<p align="center">EVERLIGHT Electronics Co., Ltd.</p> <p>Attn: No.25, Lane 76, Sec. 3, Chung Yang Road. Tucheng, Taipei 236, Taiwan (R.O.C) PHONE: 886-2-2267-2000 FAX: 886-2-2268-5240</p>	
<p align="center"> <input checked="" type="checkbox"/> PRODUCT/PROCESS CHANGE NOTIFICATION <input type="checkbox"/> PRODUCT TERMINATION NOTIFICATION </p>		
PCN tracking number: PCNCH1200004		DATE: 12/12/2012
Contact: Ke Xin Jun Title: E-mail: xjke@everlight.com	Phone: 0760-89829100 ext: 1402 Fax: 0760-89829101-1466 Mobile: N/A	
Product influenced: All of 1003 series Lamp products and MV5X124 series Lamp products. <input checked="" type="checkbox"/> Major change <input type="checkbox"/> Minor change		
Product Identification: (e.g., affected supplier part number(s), affected product lines including specific package types, product family): All of 1003 series Lamp products and MV5X124 series Lamp products.

ATTACHMENT (1)

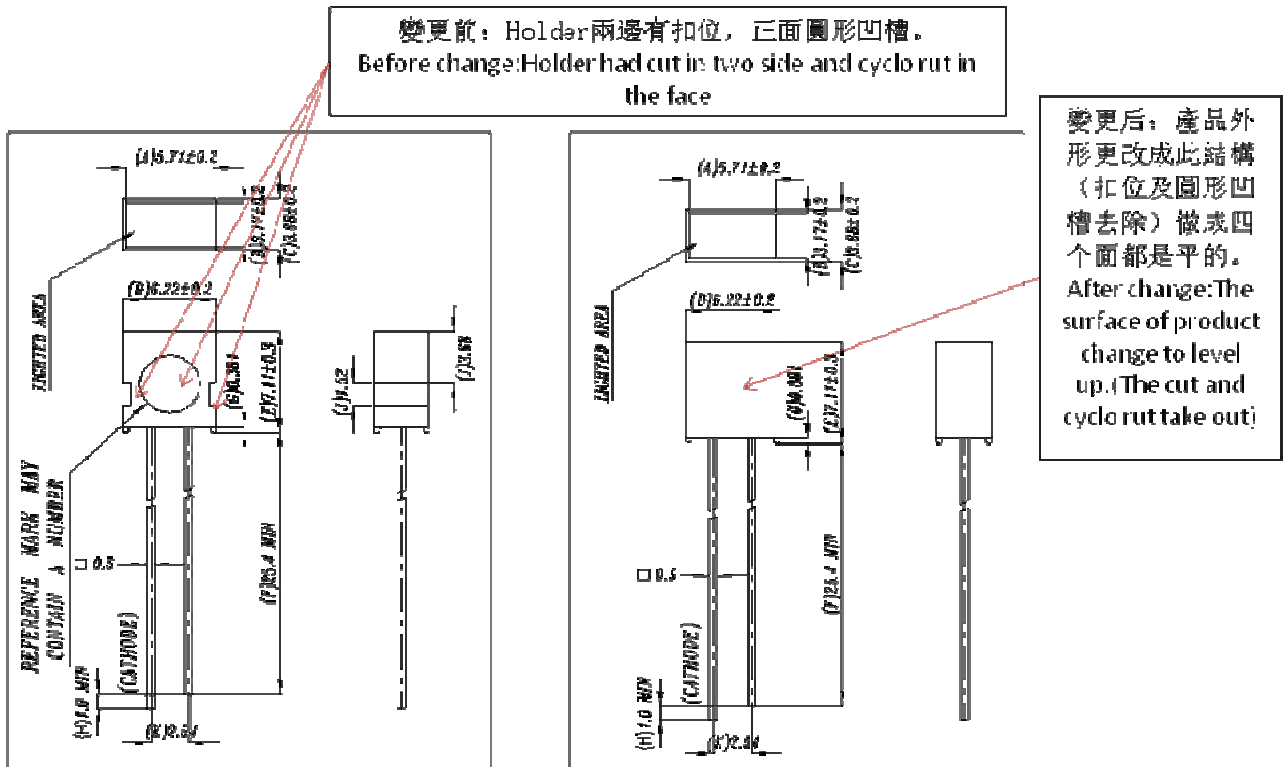
Customer part number(s) (optional, if not required per agreed to customer criteria): N/A		
Method, if applicable, of identifying changed product: Lot number since 2012/07/15.		
Reason for change(s): <input checked="" type="checkbox"/> Products Package Outline Dimension <input type="checkbox"/> Electrical/Optical Specification <input type="checkbox"/> Material <input type="checkbox"/> Equipment <input type="checkbox"/> Environment <input type="checkbox"/> Data Sheet <input type="checkbox"/> Packing <input type="checkbox"/> Other	Detailed description: 1. Due to the aging of the original 1003 cap mold, need open the new mold, in order to improve the physical appearance and to optimize the existing produce process ,so design a new appearance to replace the existing . The simple appearance structure diagram for the before and after change refer to appendix (1). 2. All Electrical/Optical specification/Part number are remain unchanged. 3. This PCN is based on the ECR000026483 which is following Everlight's internal and formal process.

Before Change:(left diagram)

After Change: (right diagram)

備註：除上述Holder兩邊有扣位，正面圓形凹槽變更外，其它尺寸不變。

PS: All other dimensions may remain, beside the The cut and cyclo rut taking out.
